Responses to Comments

Table D-1. Comments Received on the Draft Mitigated Negative Declaration

Project: Downs Substation Expansion Project/Mitigated Negative Declaration

Downs Substation Expansion Project - Initial Study/Mitigated Negative Declaration (IS/MND)

Enclosures

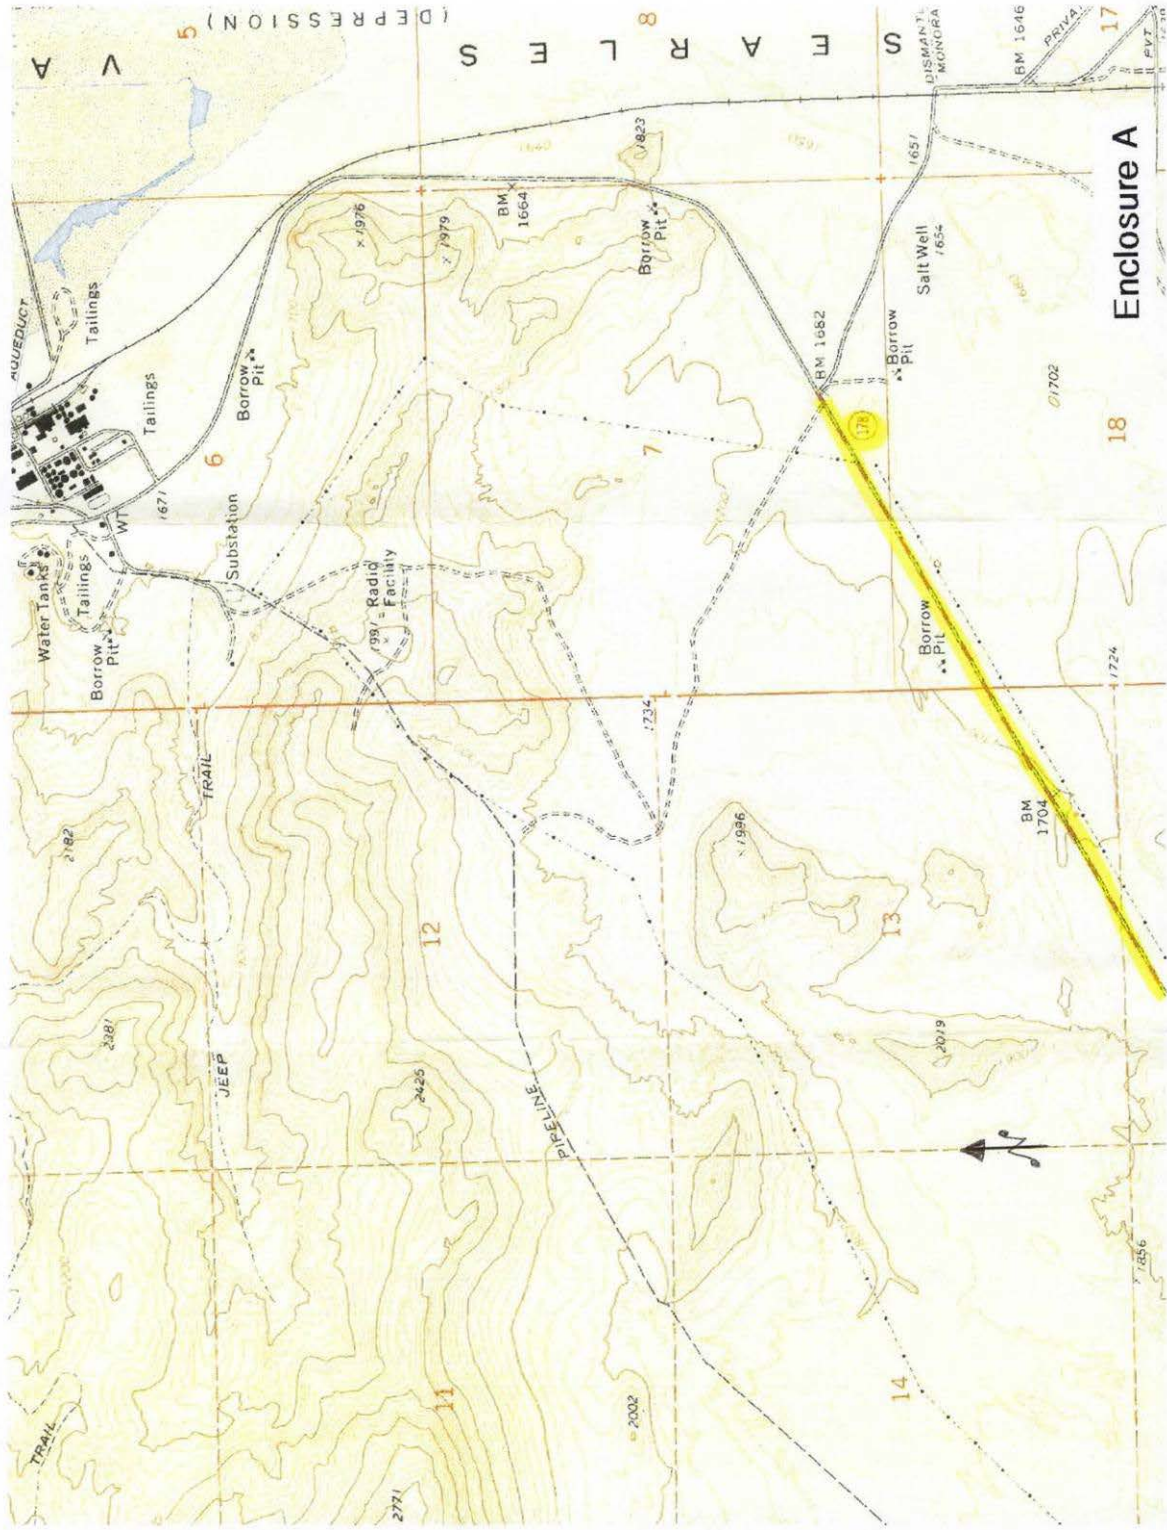
- Some project maps and diagrams incorrectly depict State Route 178 (SR-178). See the enclosed quad map excerpt and photo for clarification. The roadway continuing north from the terminus of SR-178 becomes a county road; thus, San Bernardino County is responsible for issuing permits thereon.
- As noted, oversized vehicle permits may be required. Please contact the Transportation Permits Office for Oversize/Overweight Permits in Sacramento at (916) 322-1297. See also:

- C-1 The commenter notes that some project maps and diagrams incorrectly depict State Route 178 (SR-178), and that the roadway continuing north from the terminus of SR-178 is a county road under the jurisdiction of San Bernardino County. The exact project maps and diagrams in question are not specifically noted. As such a review of all the Initial Study figures was conducted. Overall route maps provided in Figures B.1-8 and B.1-9 correctly show the highway in gold color and the county road in grey. In reviewing the road labels on other maps, Figures B.1-13 and B.1-15, and the inset maps of Figures B.3.4-2 through B.3.4-9 have been updated in the Final MND/Initial Study to correct labeling of the roadway north of the terminus of SR-178 to Trona Road and/or eliminate labeling of SR-178 north of Trona (as originally shown on the inset maps of Figures B.3.4-2 through B.3.4-9).
